Application for Variation of Conditions

Existing Planning Consent Ref: 2023/1029

Site Address: Cannon Hall Museum, Bark House Lane, Cawthorne,
Barnsley, S75 4AT

1. Amendments to the covering of the lightwell within the western lower flat roof at Cannon Hall.

Figure 01: Existing Polycarbonate Roof over the lightwell

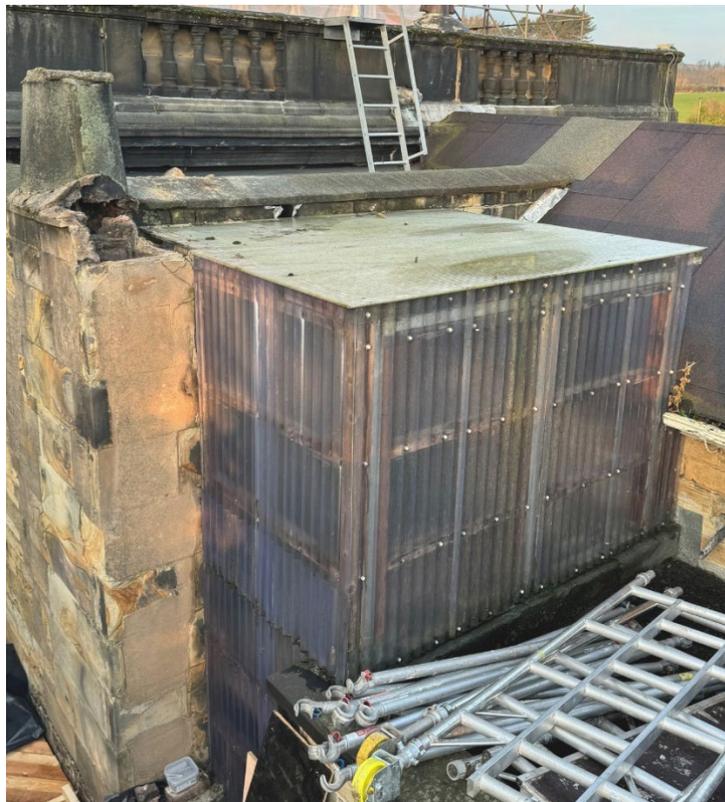
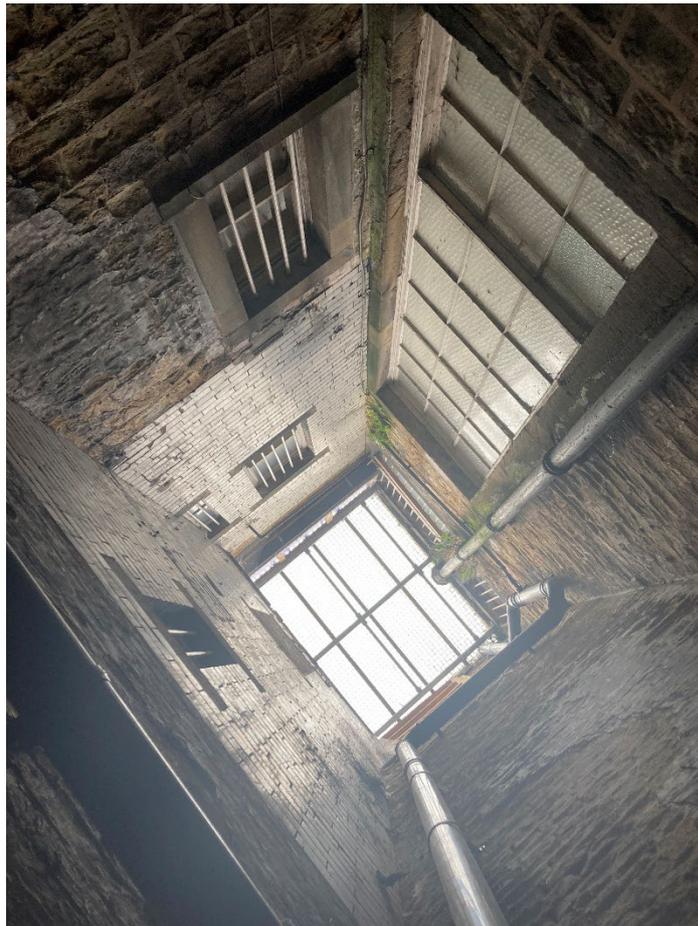
It was identified that the existing polycarbonate roof was of detrimental impact to the structures heritage, being of modern materials which were not in-keeping with the surrounding structure's character. Furthermore, it was not a robust structure, likely constructed at low cost.

Site works identified the internal drainage within the lightwell as inadequate for the quantity of water it was to receive from the revised roof conditions. Installation of the consented grille would allow rainwater to directly enter this space, requiring higher levels of water to be managed by drainage provisions at ground floor level. The consented proposals would also increase the risk of further decay to the glazed brick walls of the lightwell and historic joinery present in the space.

The revised proposals are for the installation of a new conservation rooflight to the majority of the lightwell with a surrounding code 8 gutter. A new rainwater sump and downpipe will carry water to the lower segment of this roof area.

The amended proposals seek to revise this situation by creating a direct barrier between the lightwell and water. A new code 8 lead roof is a much more robust detail which would channel water to the drainage provisions on the outside of the building. Furthermore, this new solution would mitigate the maintenance risk of decay to the internal joinery and finishes, and avoid the need for internal drainage pipes. A conservation rooflight will be utilised to best reflect the character
